MONROE COUNTY DRAINAGE BOARD
Thursday February 1, 2024, at 8:30 AM
Location: Showers Building Room 106D
Hybrid Meeting with Virtual Attendance via Teams

Project Name: Clear Creek Homes New Office
Engineer/Design Firm: Bill Riggert, BRCJ
Address: 72 N Oard Road
Acres: 1.81 acres +/-

Planning Number: SIT-23-15
Watershed: Cave Creek
Karst Report: Not Completed
Wetland Delineation: Not Completed

Project Name: The Trails at Robertson Farm
Engineer/Design Firm: Daniel Butler, Bynum Fanyo
Address: 4691 S Victor Pike
Acres: 44 acres +/-

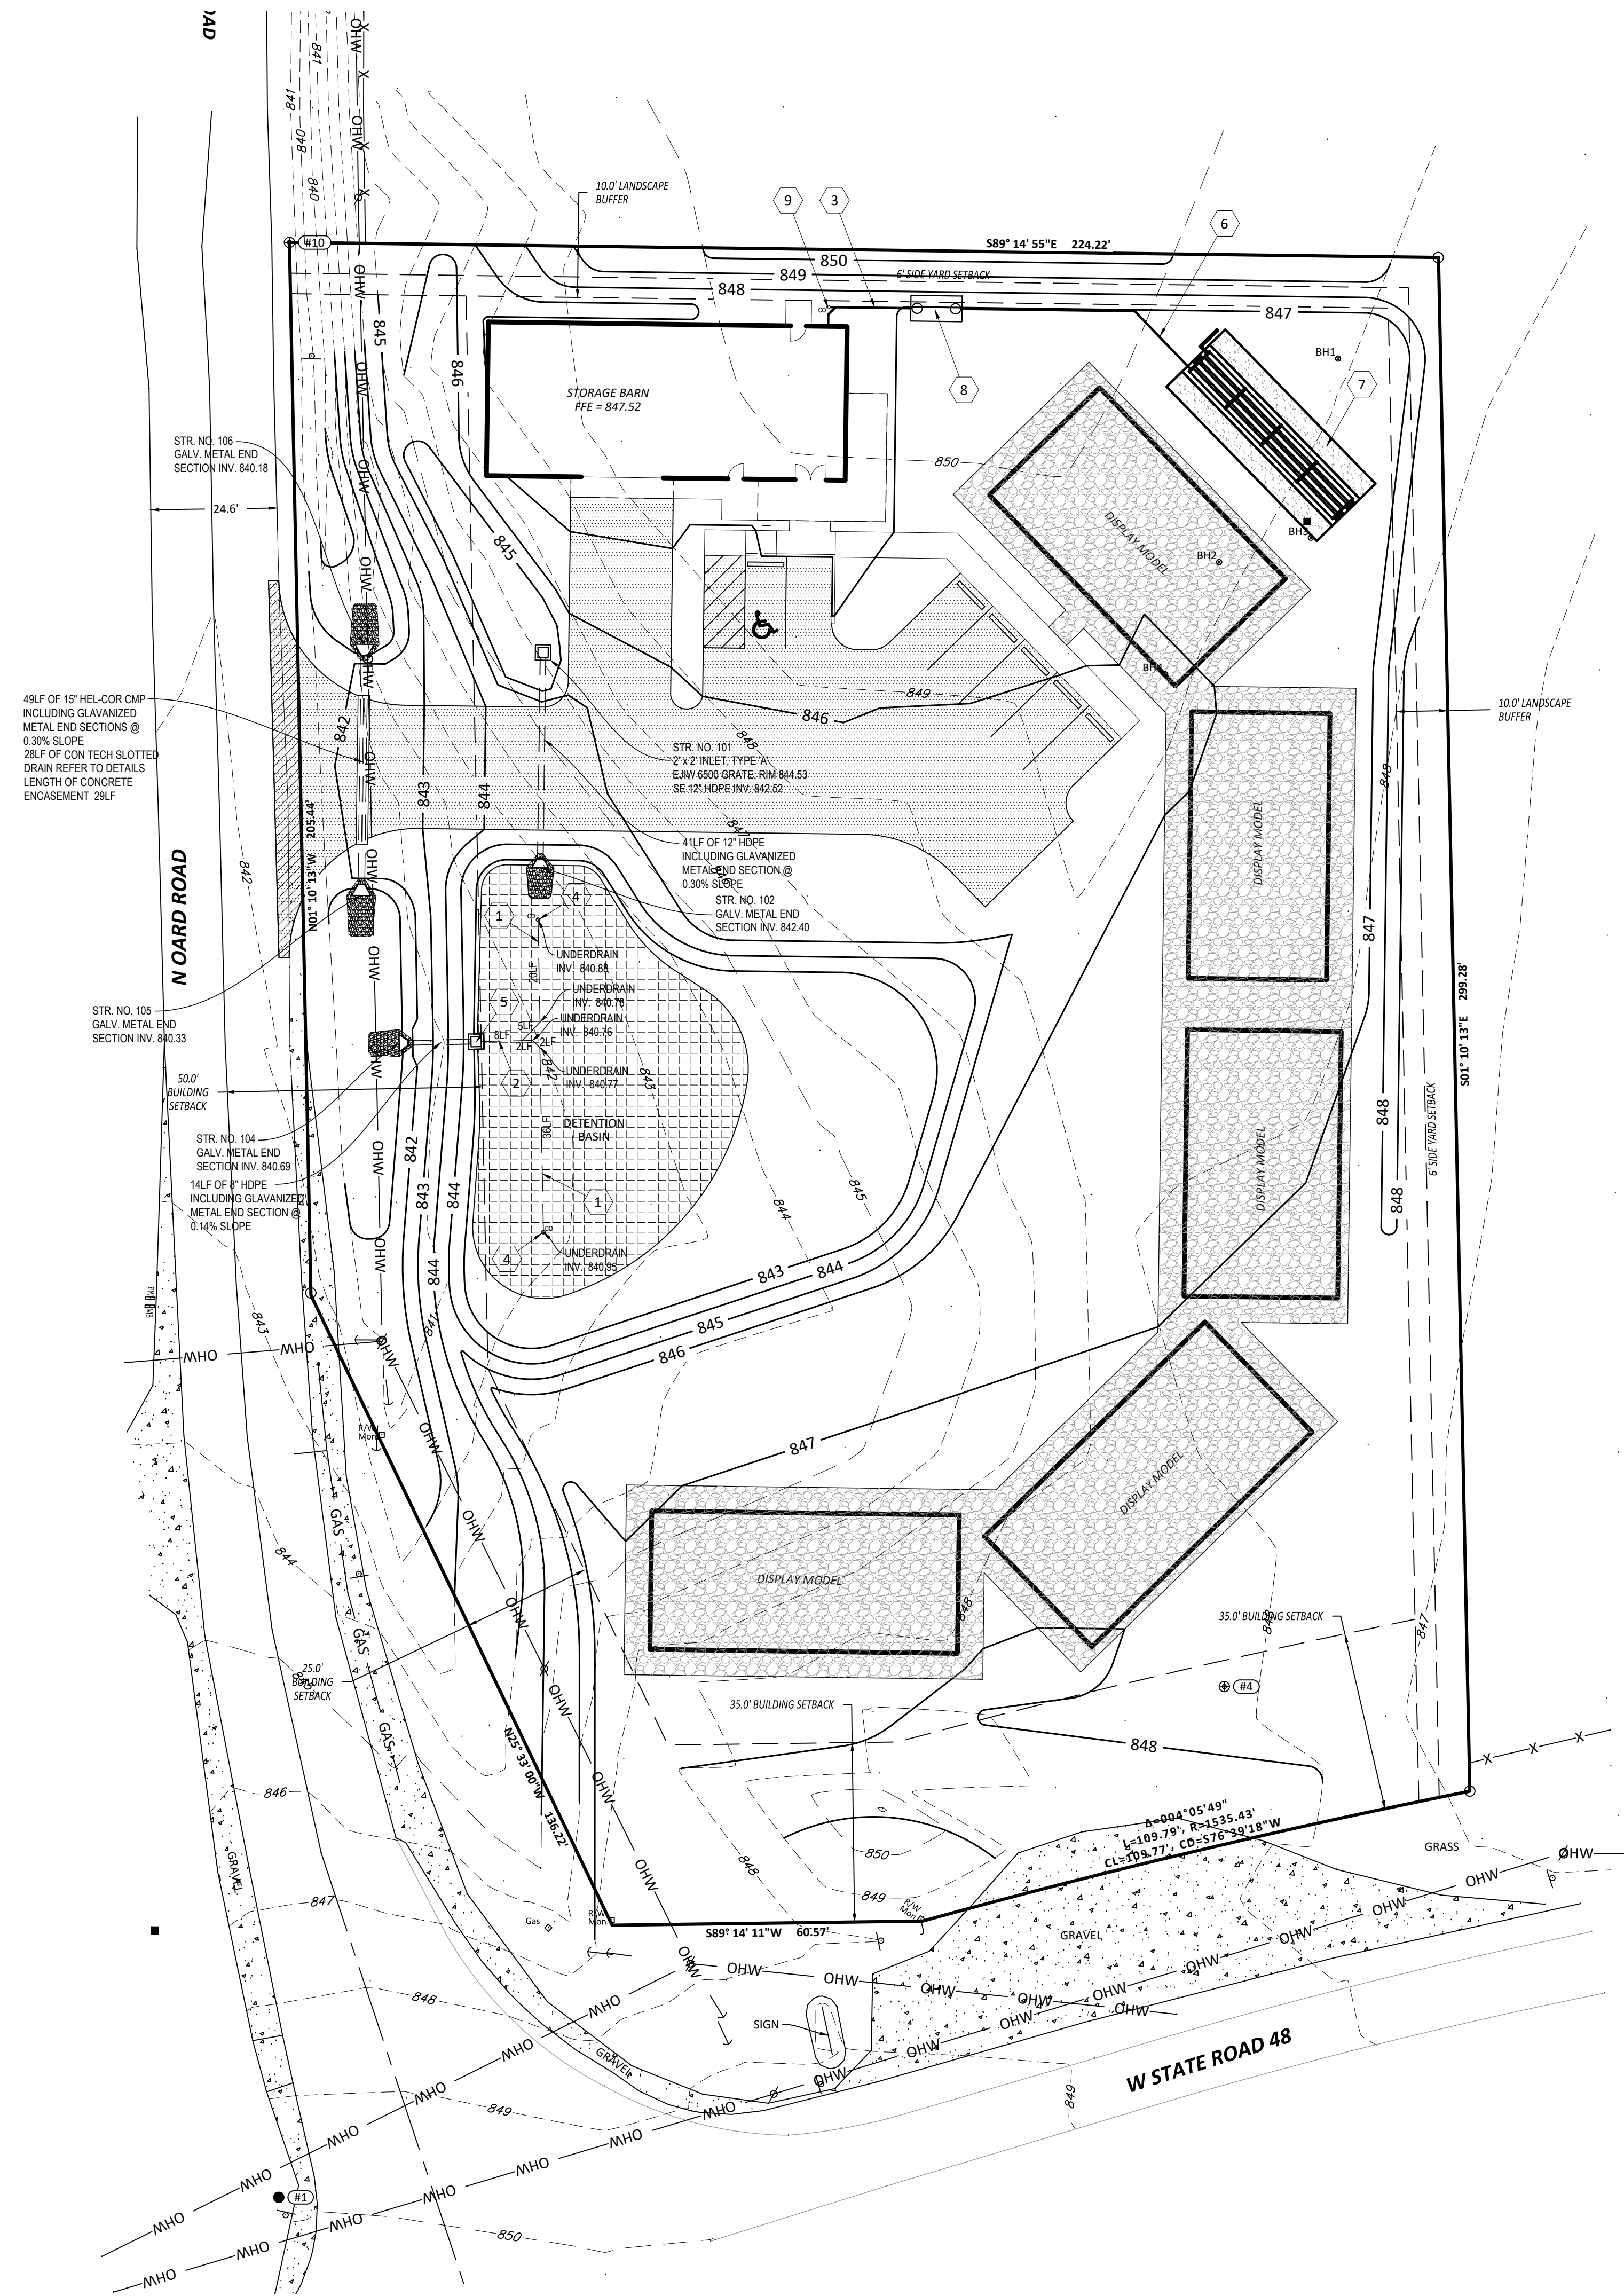
- Regrade ditch from detention pond outlet to at least the property boundary. The ditch flows north to a MC culvert under Oard Rd. This culvert outlets to a compound sinkhole on the west side of Oard Rd.  and remove proposed landscaping from the roadside ditch.

- There is a sinkhole on the south side of the property according to the 2011 Sinkhole Inventory. Verify if there is a sinkhole in this area. Place all sinkholes in SCAs and provide overflow Drainage Easements.
- Is bedrock going to be an issue for cut/fill operations?

If a pump is required for the commercial septic system, please include inspections and maintenance of the pump in the Operations & Maintenance manual.

Use updated rainfall tables in new Technical Standards Manual.

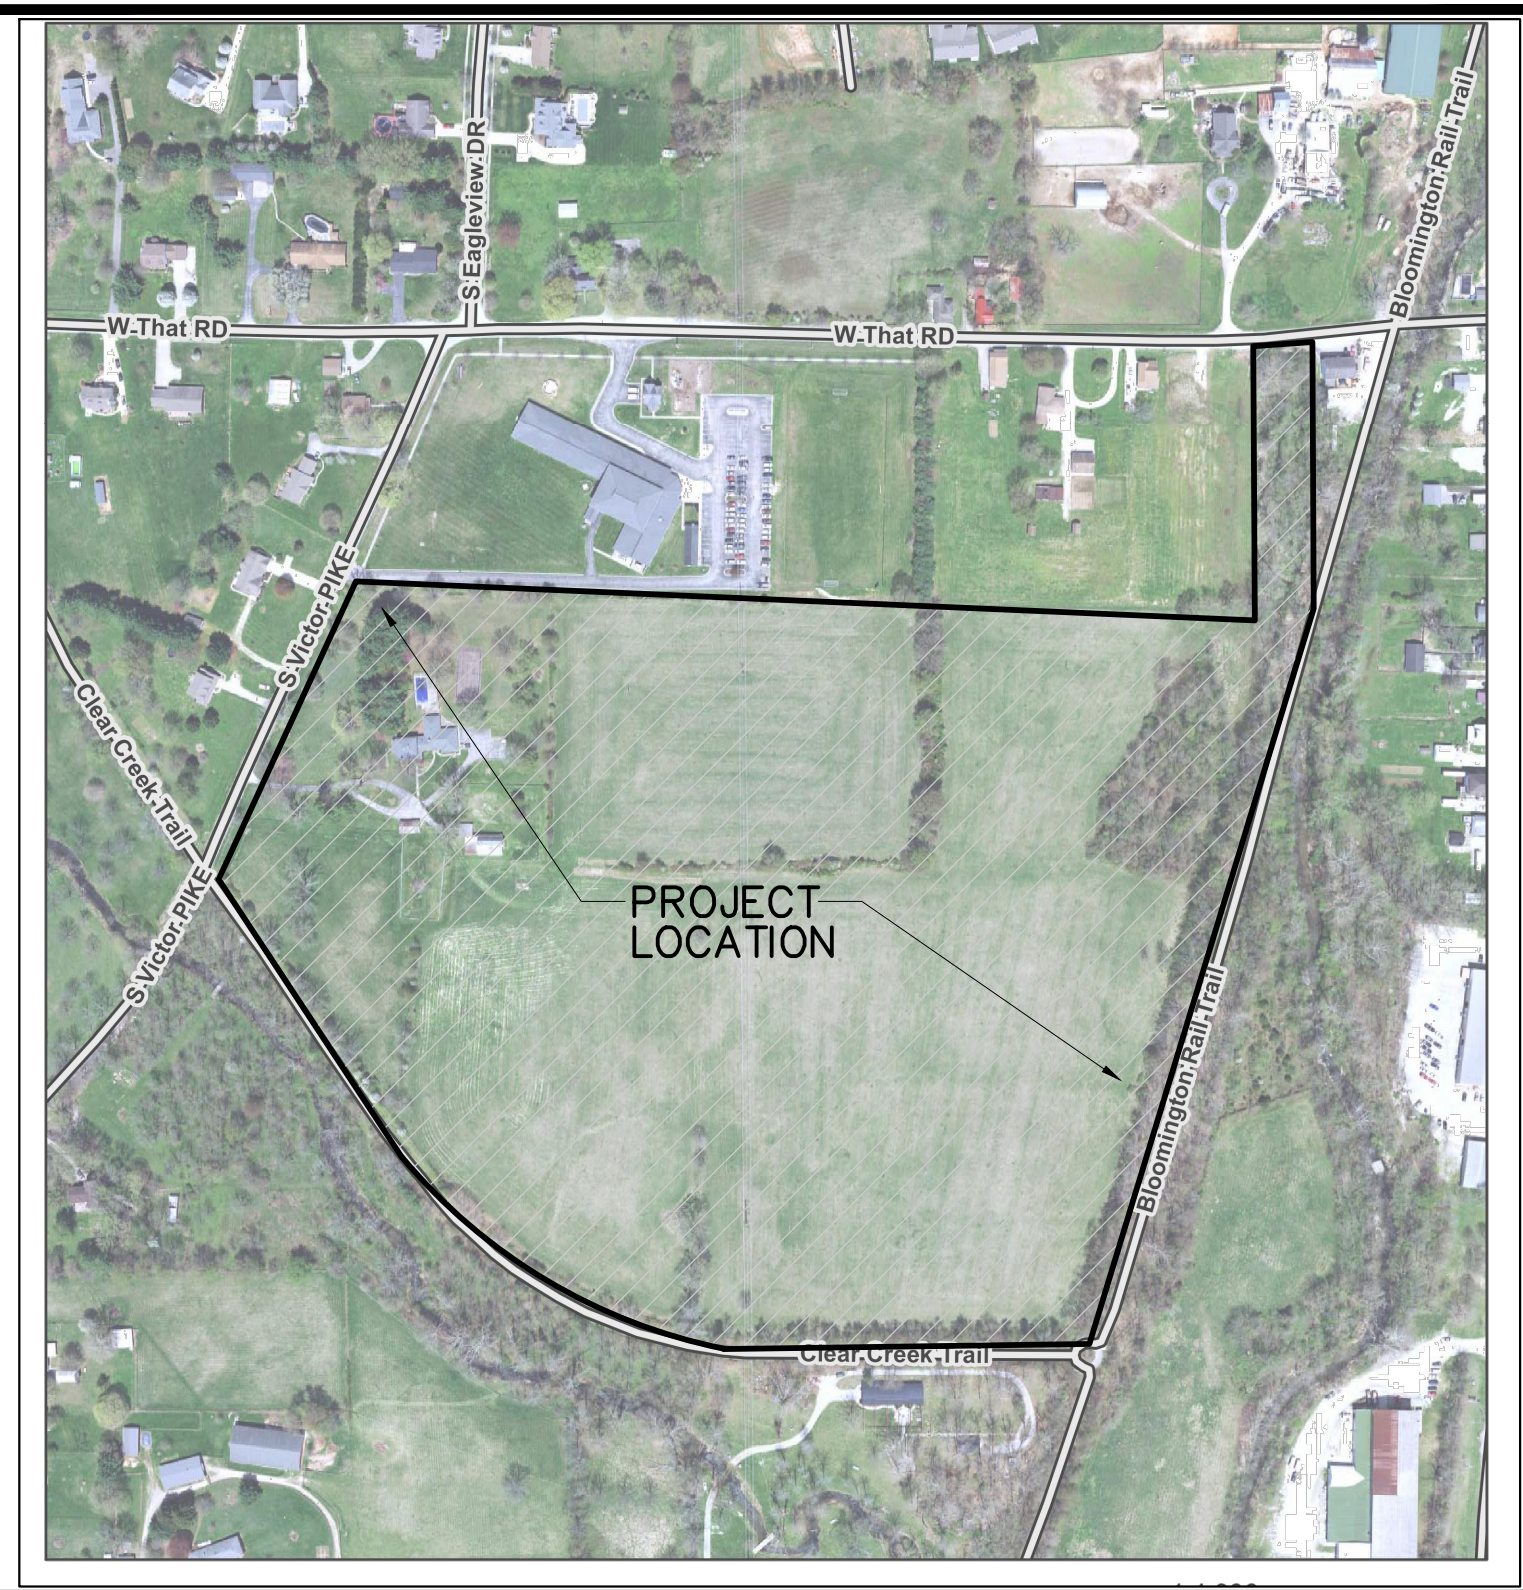
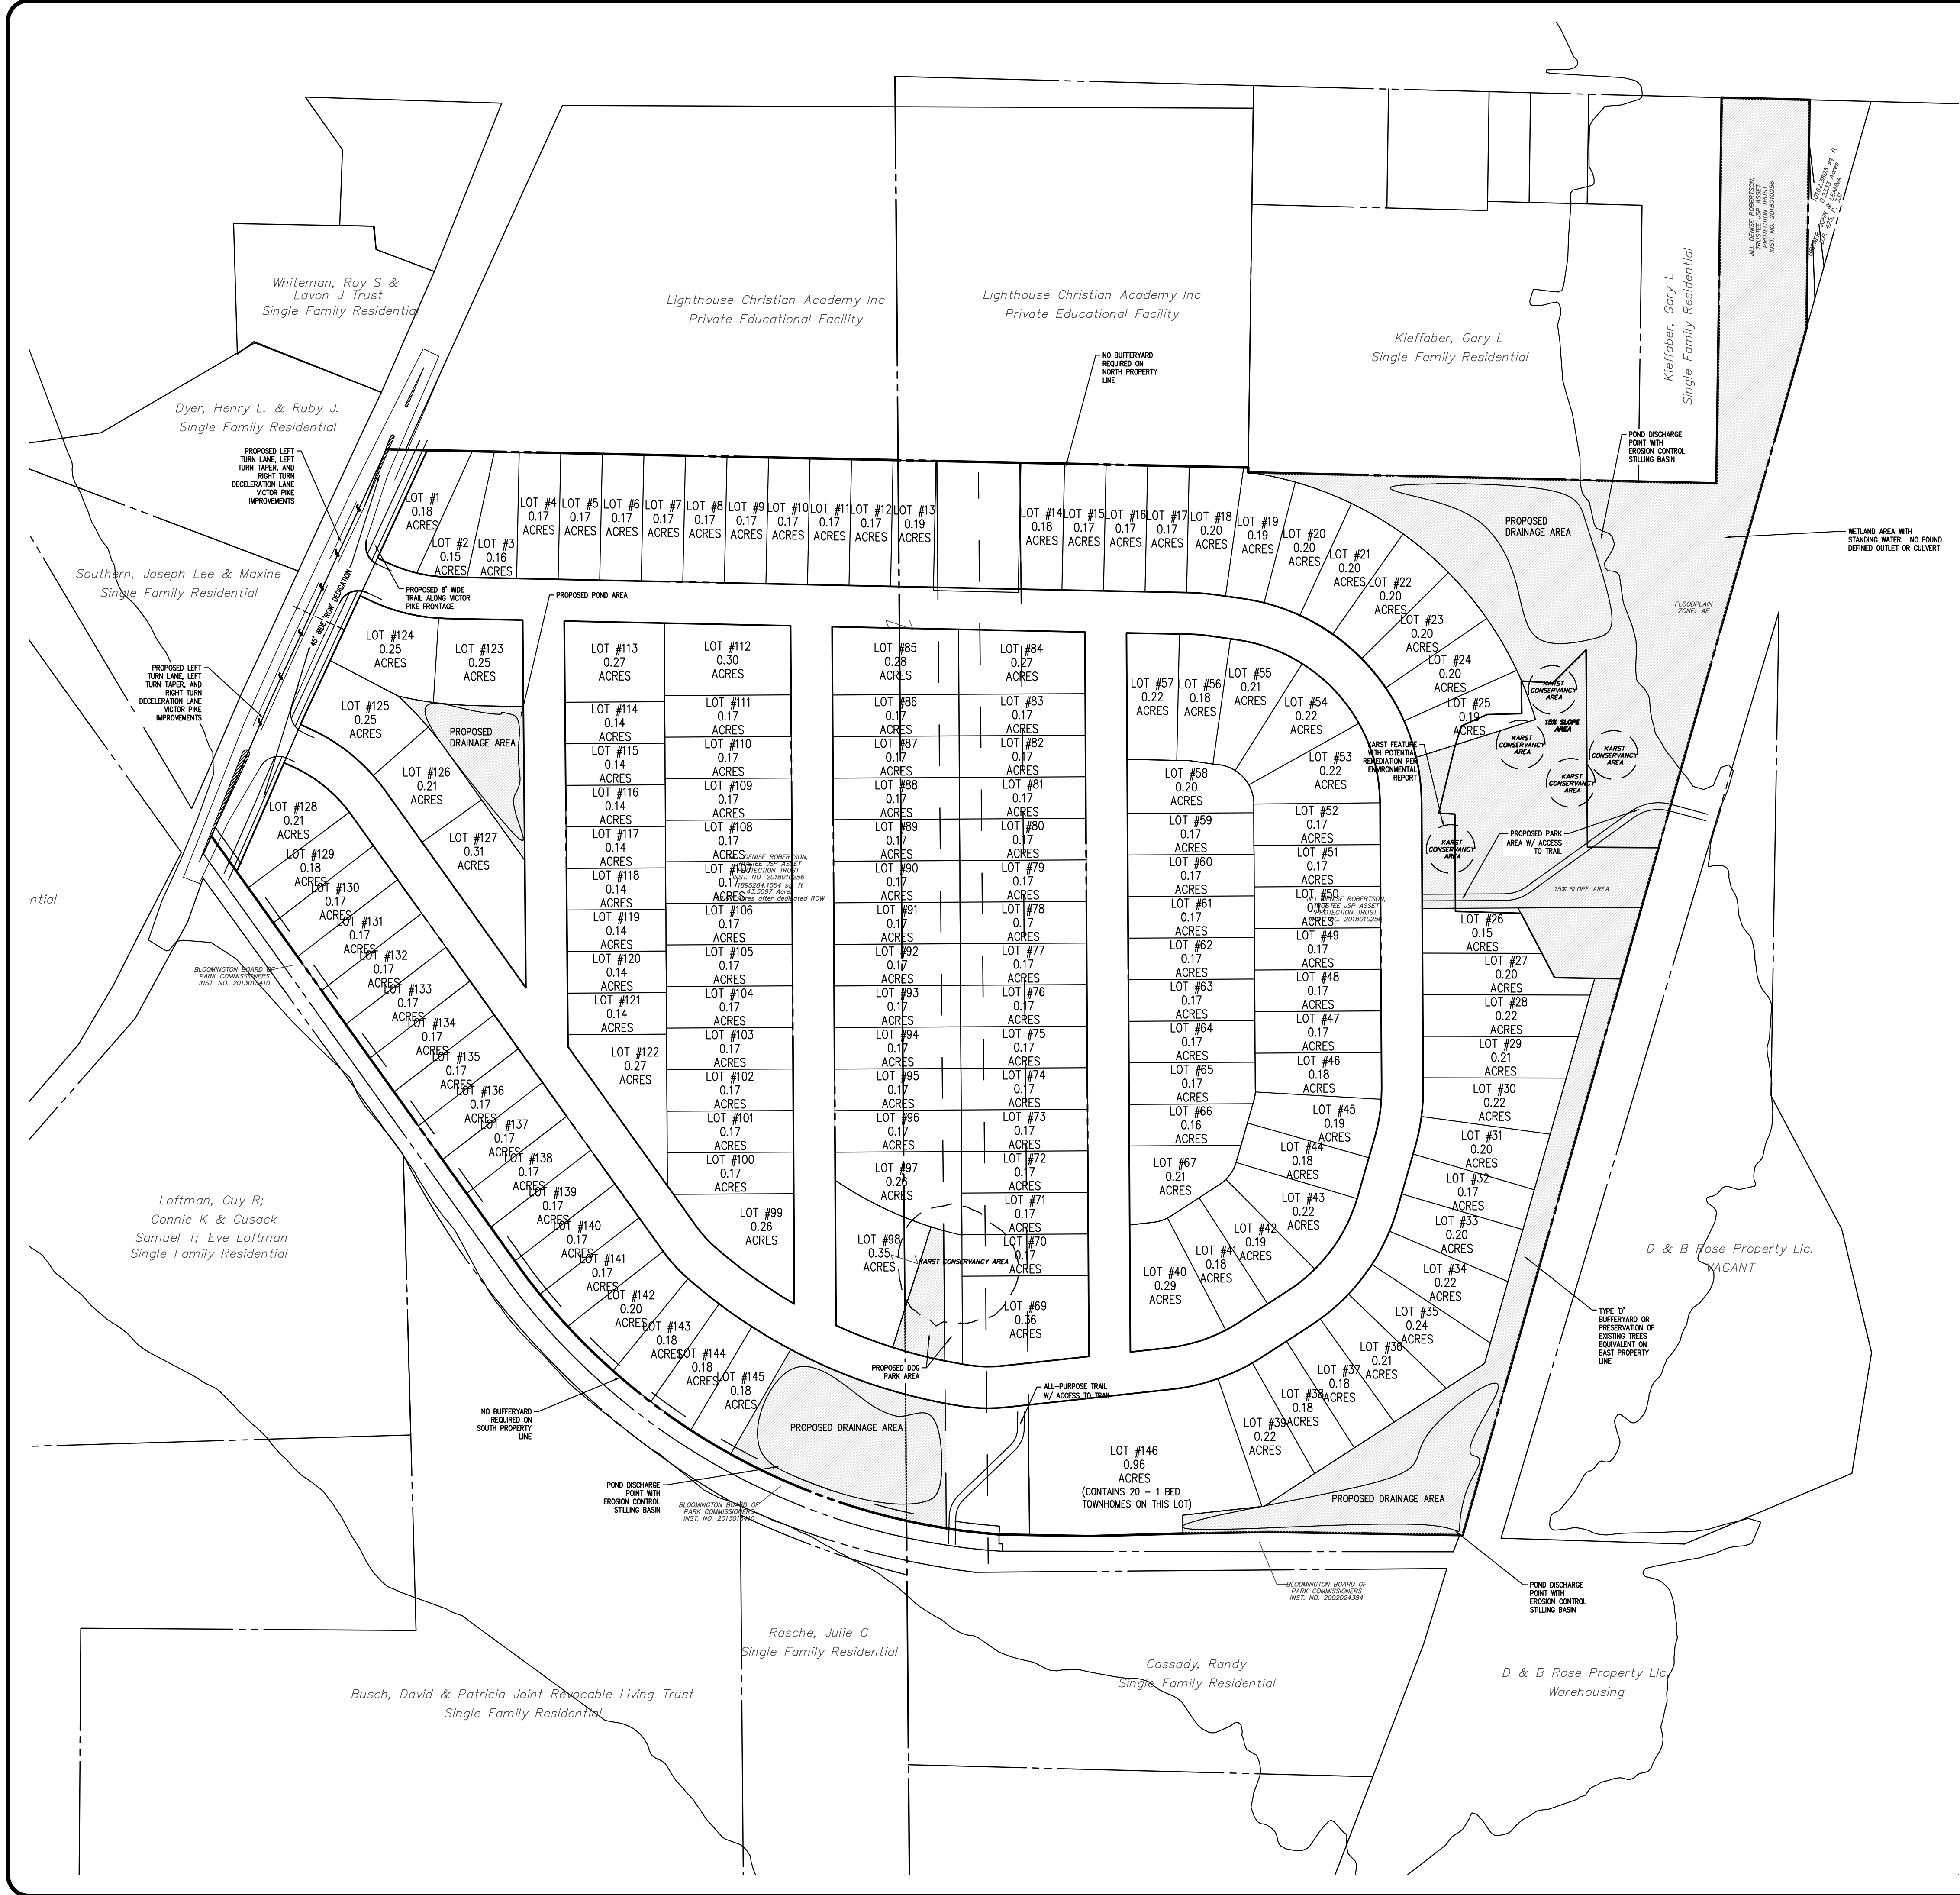
- Provide calculations demonstrating adequacy of existing culverts under the trails where ponds will be discharging.
- There is not a clear outlet for the pond at the northeast corner; in 2021, a stilling basin was proposed at this outlet. Is this adequate?

- Place sinkholes in SCAs. Provide overflow Drainage Easements for all SCAs.
- Avoid all wetlands on the property and provide additional velocity dissipation and water quality treatment for any site runoff discharging to wetlands, if the Drainage Board will allow discharges to wetlands. What other measures can we apply to the outlet of the northeast detention pond?
- Check for existing wells in the area.
- Is bedrock going to be an issue? Are significant excavations anticipated?

- Show number of trees to be removed in the detention pond areas. Provide tree replanting plan with a ratio of at least 1:1 tree replacement for any trees being removed as a result of detention ponds.
- New trees and shrubs cannot be placed on pond embankments, spillways, or within 10 ft. of any stormwater infrastructure.
